Planning Response

**Flosh Meadows
Cleator
The Meadows (SR12)
4/22/2092/001**

Report Number:
1842-PR1

The following text sets out Coast Consulting Engineers formal response to comments received relating to a proposed residential development adjacent to Flosch Meadows, Cleator, dated 12 April 2022. The comments relate to the first phase of the development only, known as SR12 – The Meadows. The initial phase consists of twenty-one self-build units located at the southern end of the wider development.

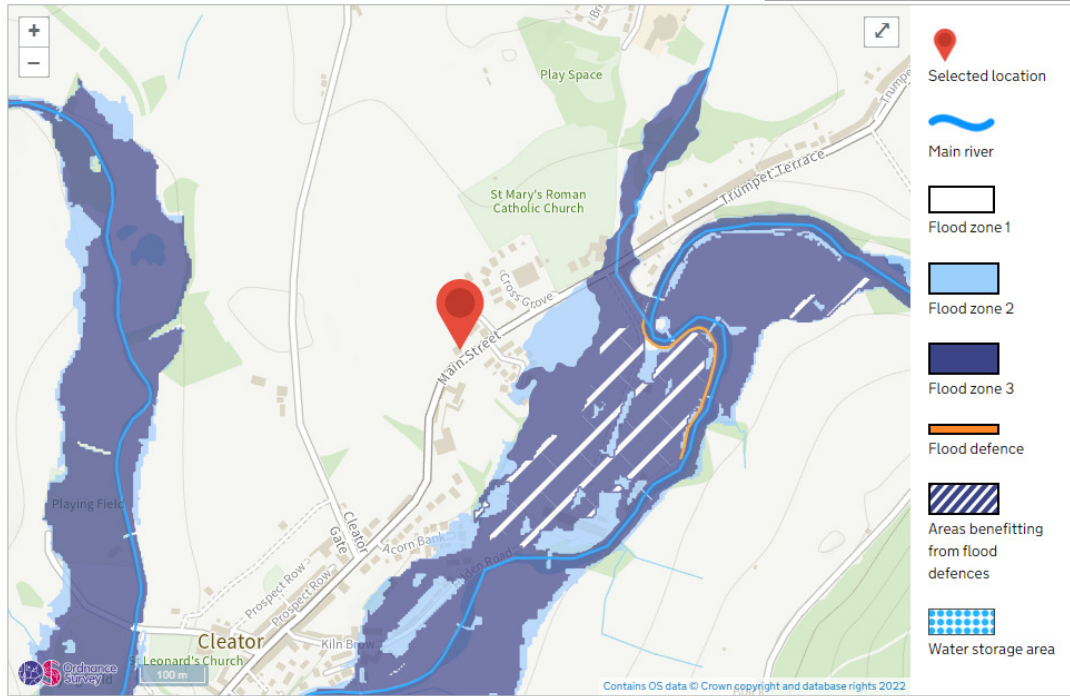
- 2.07 **LLFA comment** - *The land drain needs manholes at every change in direction, not just the silt trap, we recommend that change in direction is rethought as a change in direction at 90 degrees can cause hydraulic issues*

Coast response – Silt traps are inspection chambers (i.e non-man entry manholes for H&S reasons). 90-degree bends are allowed under the requirements of Building Regulations document H.
